NETWORK RAIL (HUDDERSFIELD TO WESTTOWN (DEWSBURY) IMPROVEMENTS) ORDER

Calder Road – Design Refinement

Document Reference	151667-TSA-00-TRU-CNT-W-LP-000318
Author	Network Rail
Date	08 November 2021

APPENDIX C – CONSTRUCTION PHASING

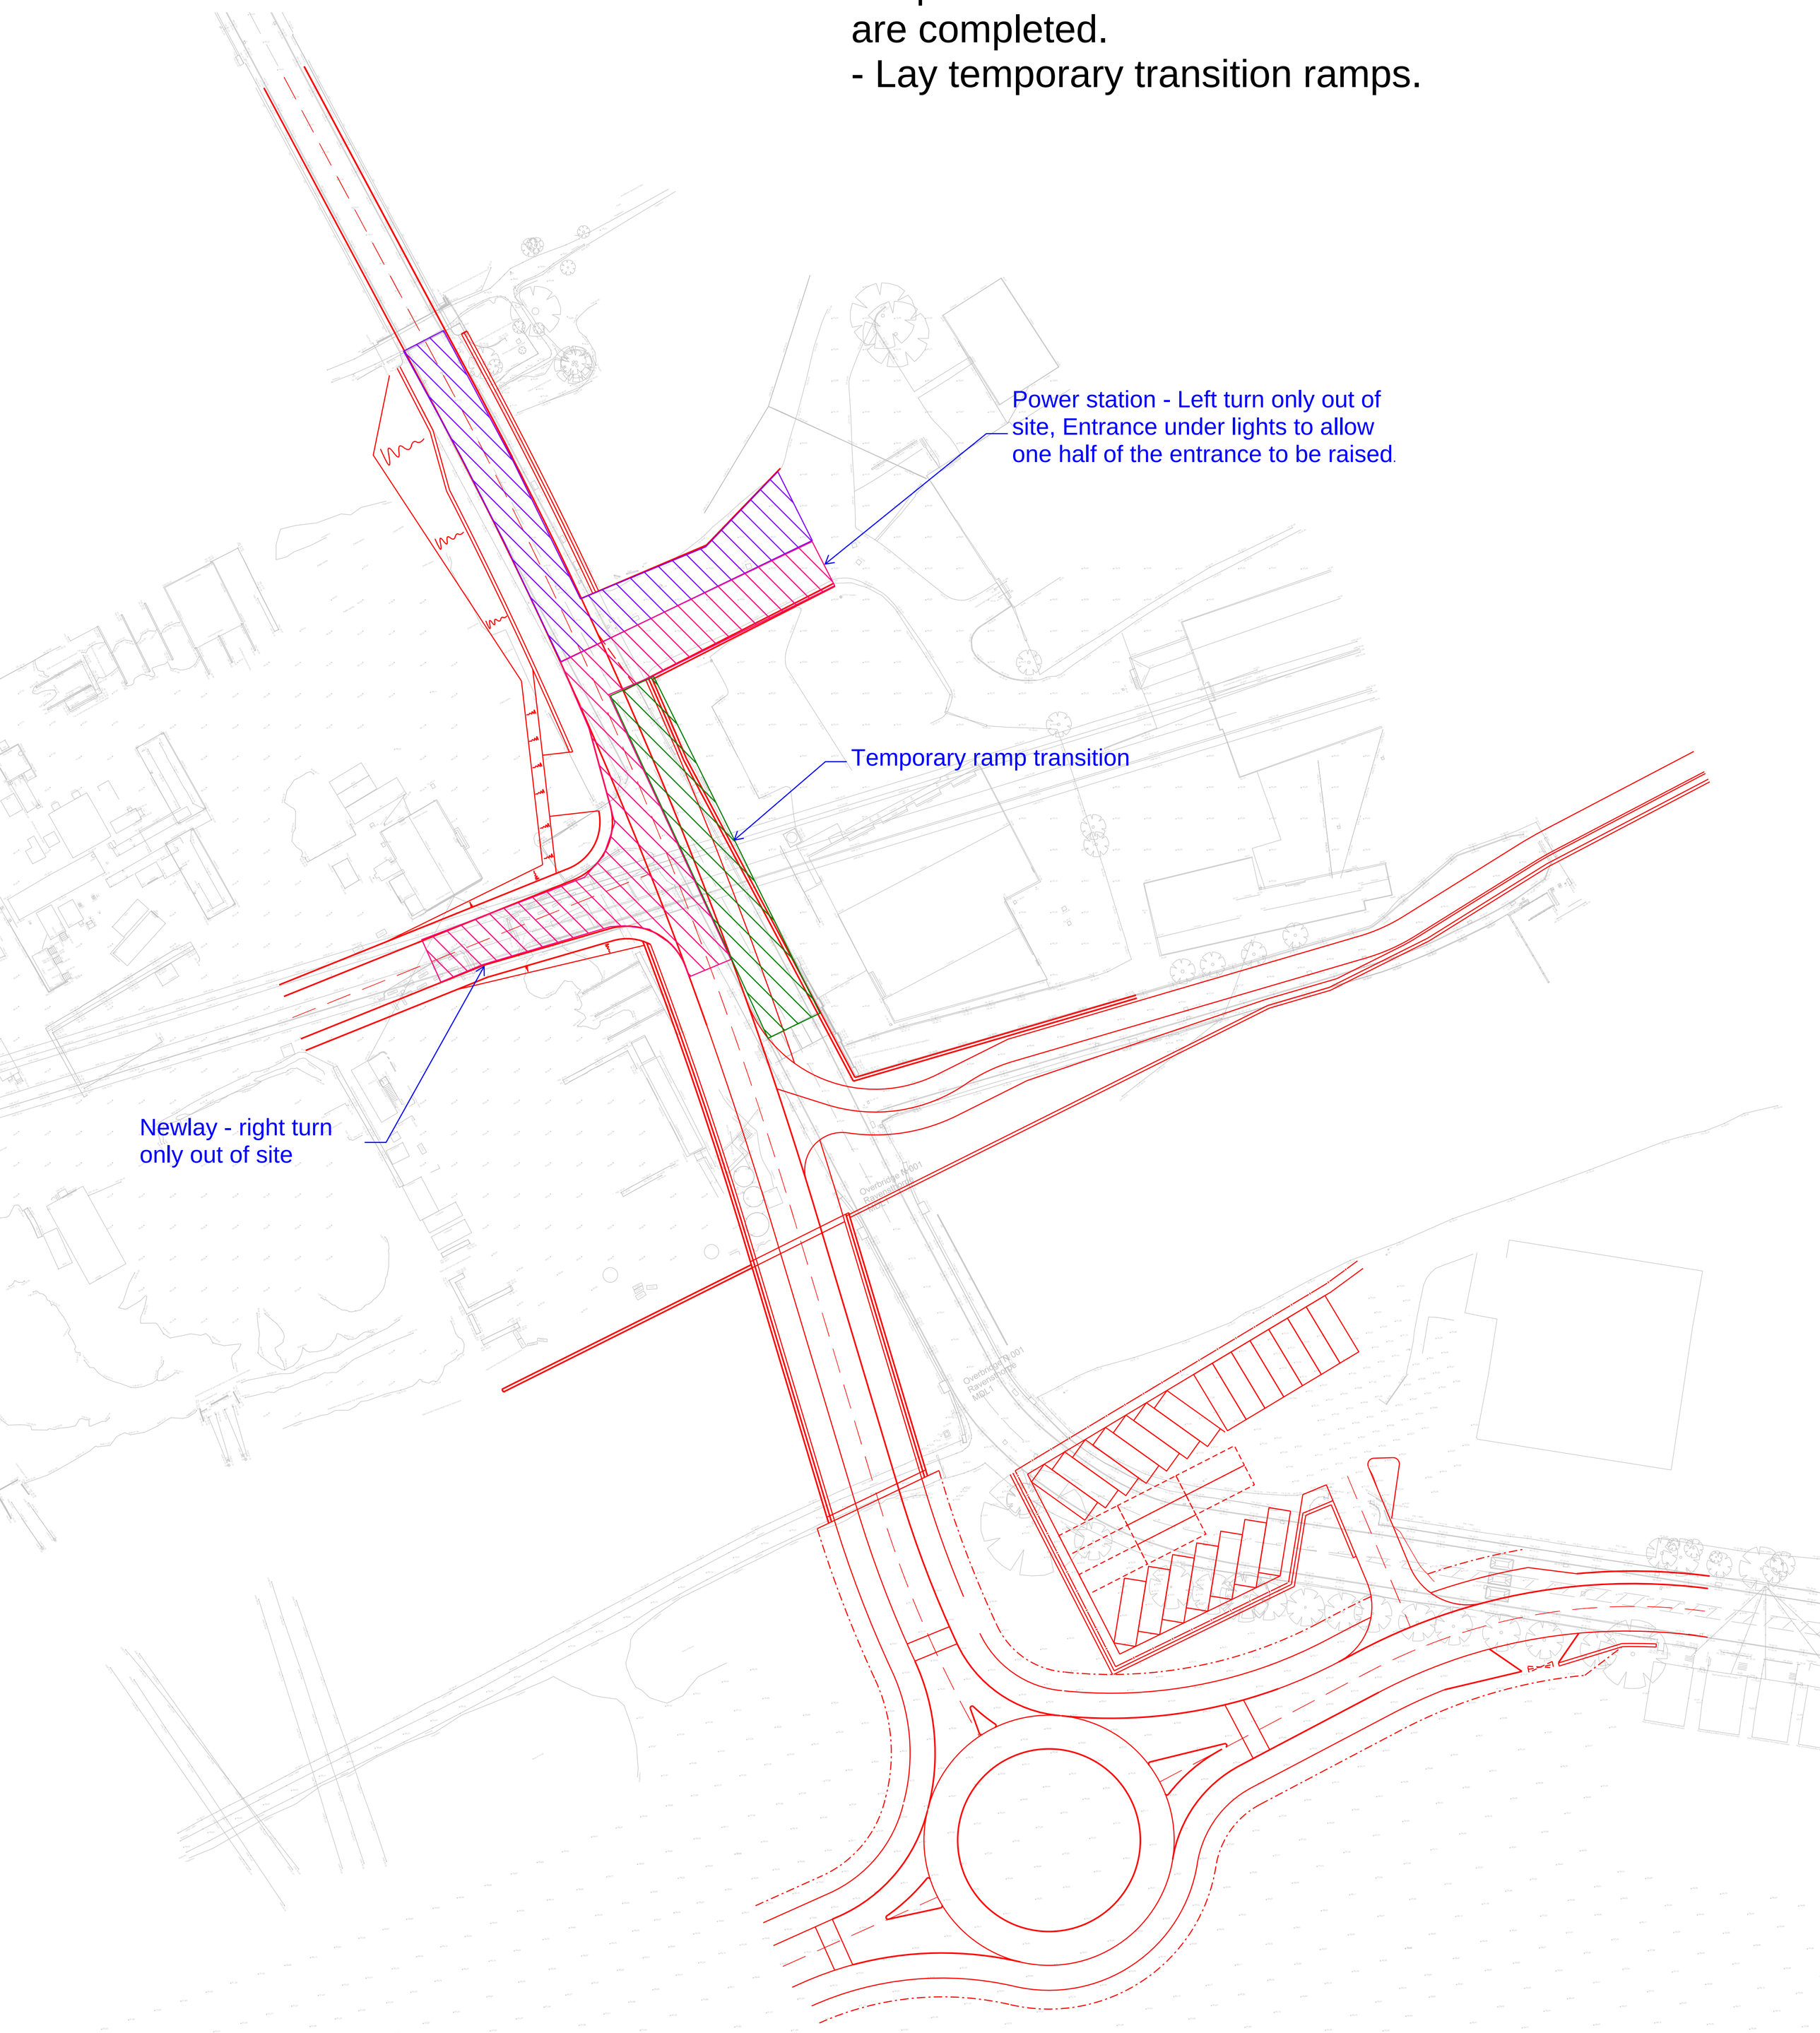
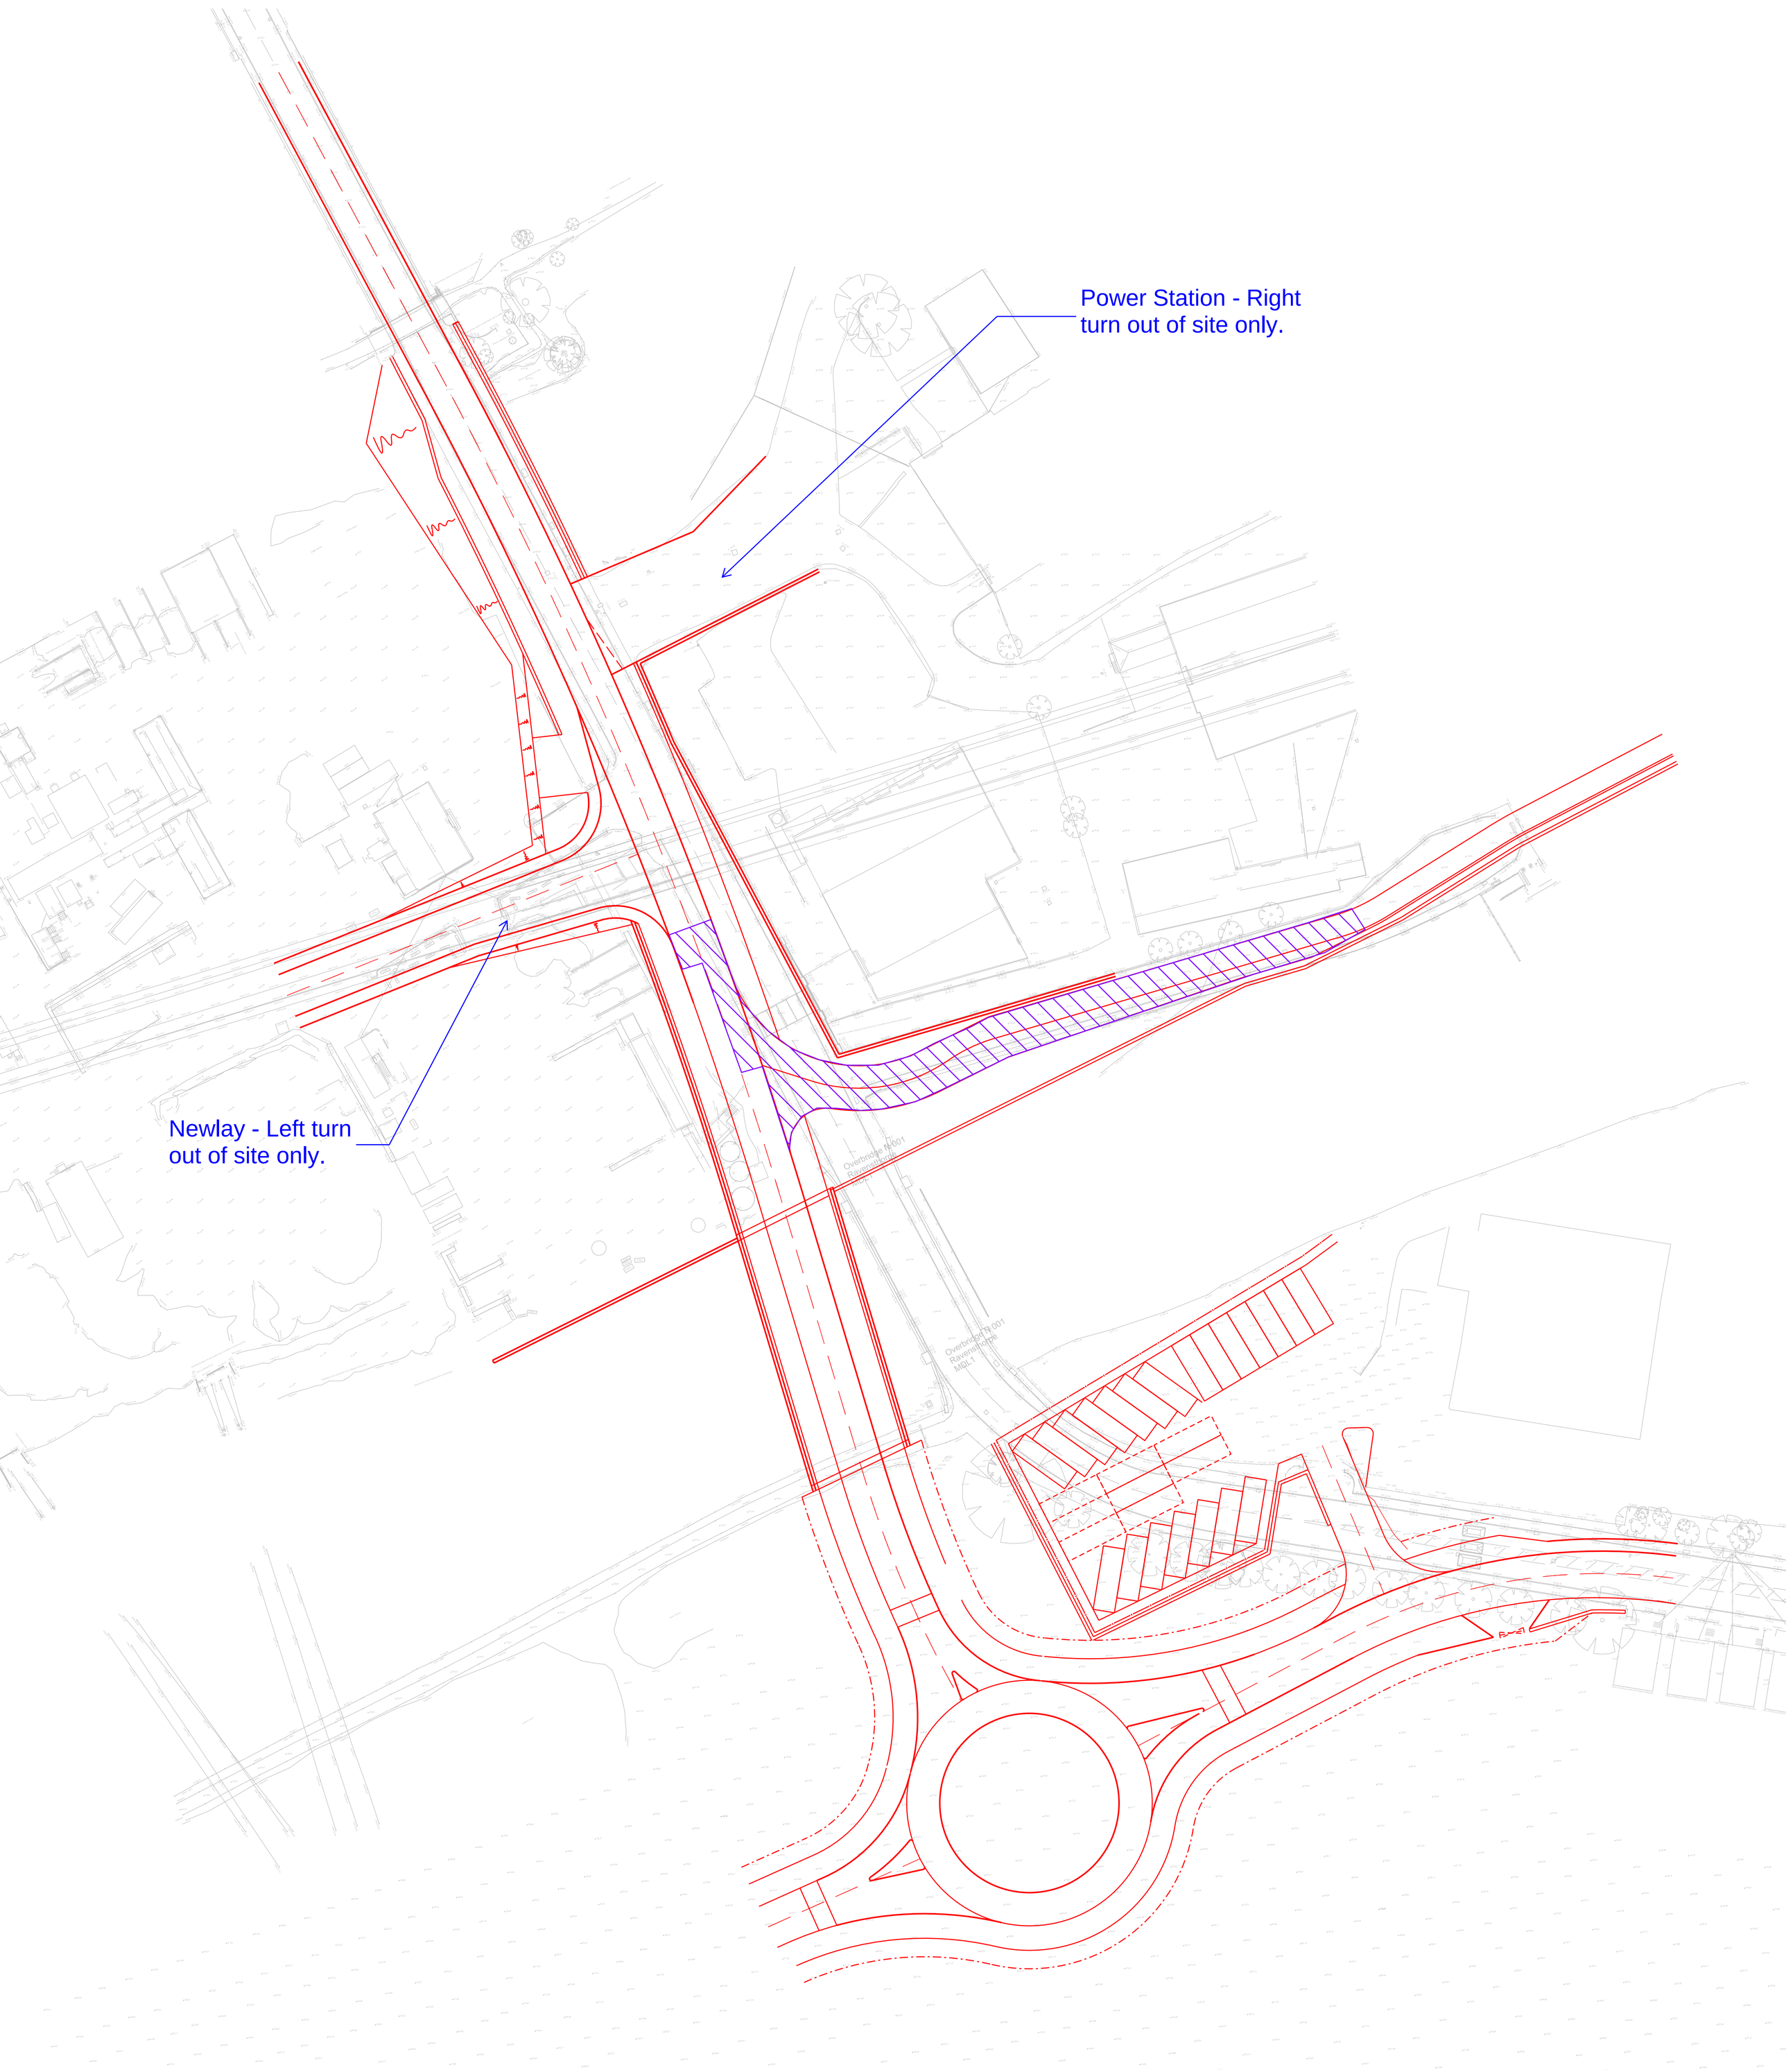
- Reconfigure Newlay Readymix Plant
- Temporary access through Newlay site to construct new rail facing retaining wall along slow line.
- Potential to divert overhead cables.

- Construct rail facing retaining structure, Calder Road bridge abutment and off line highway.
- Traffic management over Calder River bridge - single lane running to allow reconstruction of parapet string course and parapets.

- Close Calder Road river bridge for level raising and resurfacing works
- Weekend opening of river bridge to provide access to the power station while second half of entrances works are completed.
- Lay temporary transition ramps.

- Close existing station access and Calder Road south of Newlay site entrance.
- Construct road between the Phase 1 limit and Newlay site entrance.

- Weekend/ Bank holiday closure of Newlay entrance to allow completion of road raise.
